Subject: Continued airworthiness; precautions against elevator flutter.

Affected gliders: All ASW 19 and ASW 19 B; serial numbers 19001 thru 19402 with the exception of 19019 and 19210.

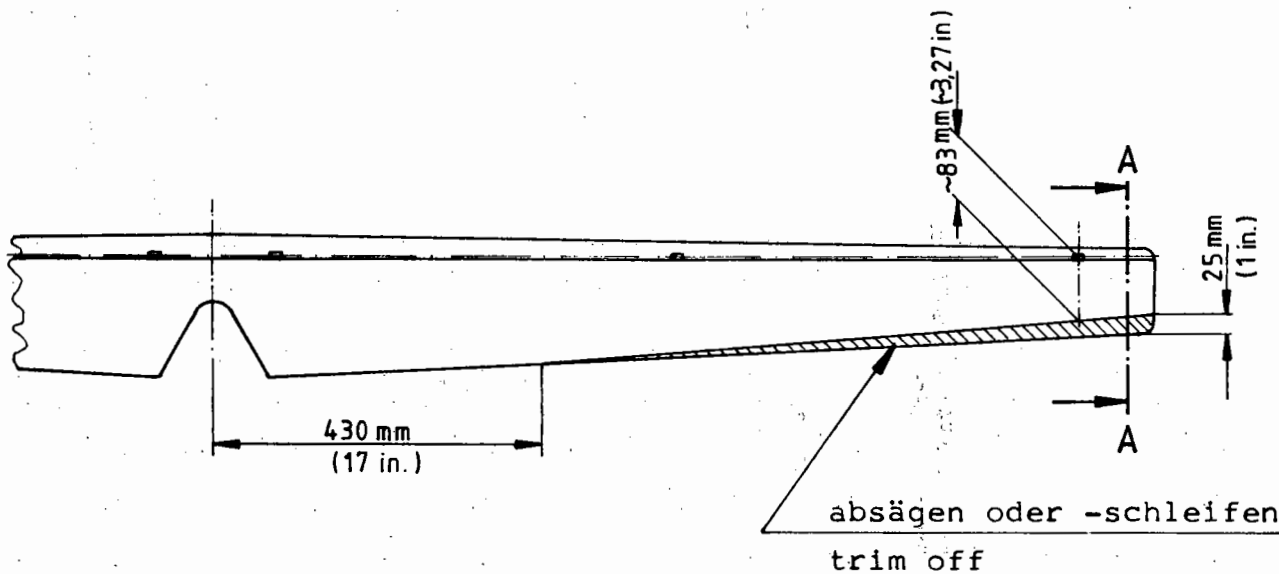
A further flutter calculation showed that a trimming of the elevator trailing edge mainly in the tip region (see sketch on sheet 4 and also corrected drawing 190.35.S1) removes the possibility of above flutter cases within the approved speed limits, even if the elevator control circuit is weakened or partially damaged.

2. According to the sketch on sheet 4 of this TN, the elevator trailing edge is cut or ground off and reshaped on the lower surface.

The glue joint must be at least 7 mm wide, but no more than 12 mm.

The mass reduction by trimming and reshaping the trailing edge has the same effect as a much heavier mass balance in front of the elevator hingeline. Therefore, it is important to remove as much weight as possible from the trailing edge and to reduce a necessary glue joint to a minimum.

Verleimung, glue joint

min. 7 mm (0,28 in.)
max. 12 mm (0,47 in.)

Hinterkante verjüngen
reshape trailing edge

alte Kontour
old contour
